Intel® Pentium® III Processor Specification Update

Release Date: December 2001

Order Number: 244453-036

Pentium® III Processor with 512KB L2 Cache Platforms Workaround

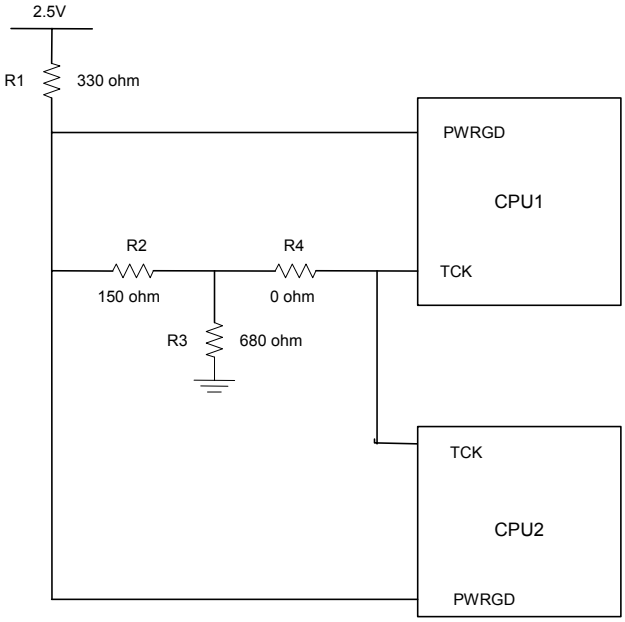
Workaround: To prevent the risk of power-on boot failures or catastrophic thermal failures, a platform workaround is required. The system must provide a rising edge on the TCK signal during the power-on sequence that meets all of the following requirements:

- The example workaround circuit assumes that the PWRGD inputs into the processors are open collector. Tying the PWRGD inputs together in a Wired-AND fashion allows each processor to receive PWRGD at the same time but at the latter of the 2 separate PWRGD assertions. If separation of the PWRGD inputs to each processor is required, extra circuitry will be required.

Assumes the inputs to the CPU_PWRGD are open collector signals that are Wire-ANDed together
